**TAYLOR COUNTY COMMISSION
TAYLOR COUNTY, WEST VIRGINIA
TAYLOR COUNTY HEALTH DEPARTMENT NEW FACILITY**

ADDENDUM #2

MAY 17, 2022

THRASHER PROJECT #060-10186

CONCRETE PARKING BUMPER DETAIL

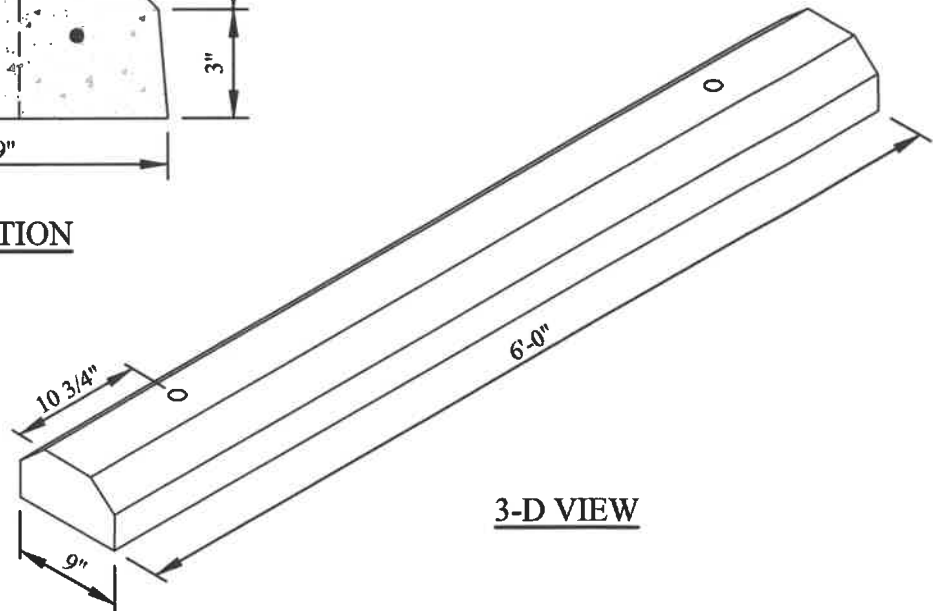
25. Are parking blocks in GC package? If so, what type do you want to use?

Yes. Concrete parking blocks per the detail shown on the attached sheet. Also see question 2.

TEMP-GARD III SHOWER UNIT

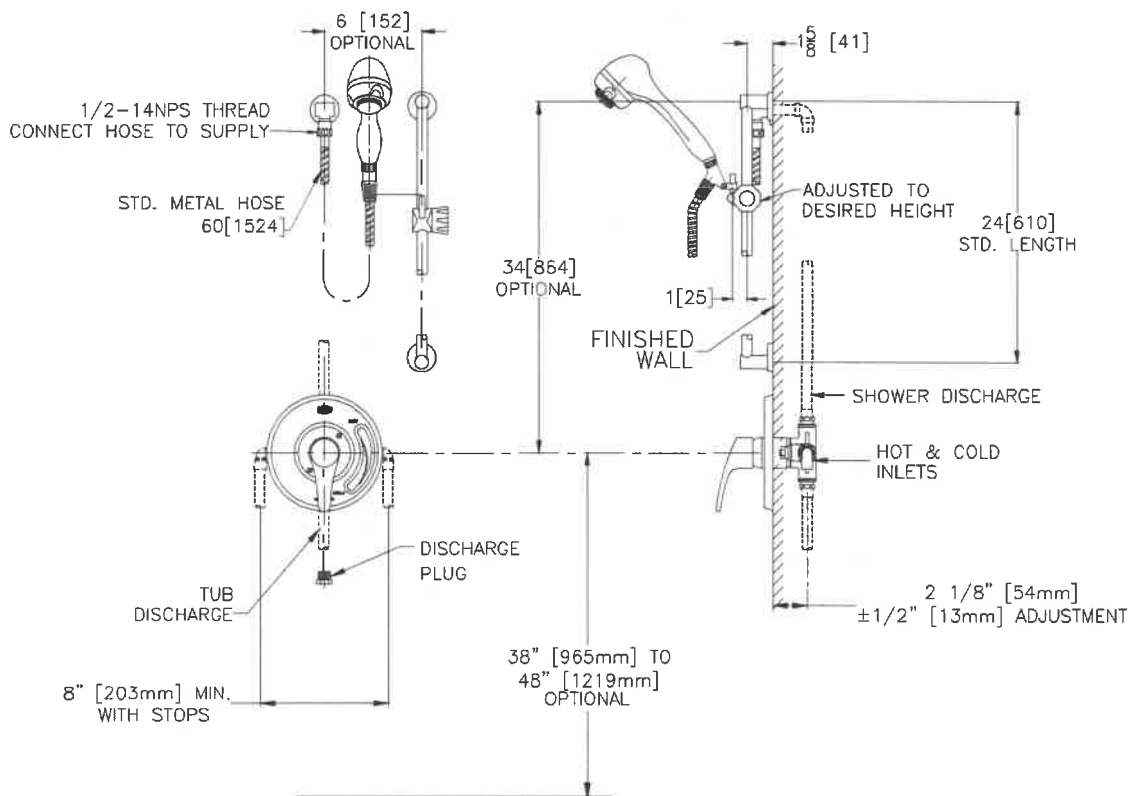
12. Does restroom 005 receive same toilet accessories as 006 detail 6/A4.01 or are these at a later date?

Yes. In addition, Shower Room #003 is to have the same fixtures and accessories as 005 & 006, plus an acrylic or fiberglass shower unit with curtain rod. The Shower Room was omitted from the Ground Floor Plan, but it is similar to the layouts shown on the Plumbing Plan. P1.03 Refer to Drawing P5.01, Shower Rom 003: shower shall be tagged SH-1H.
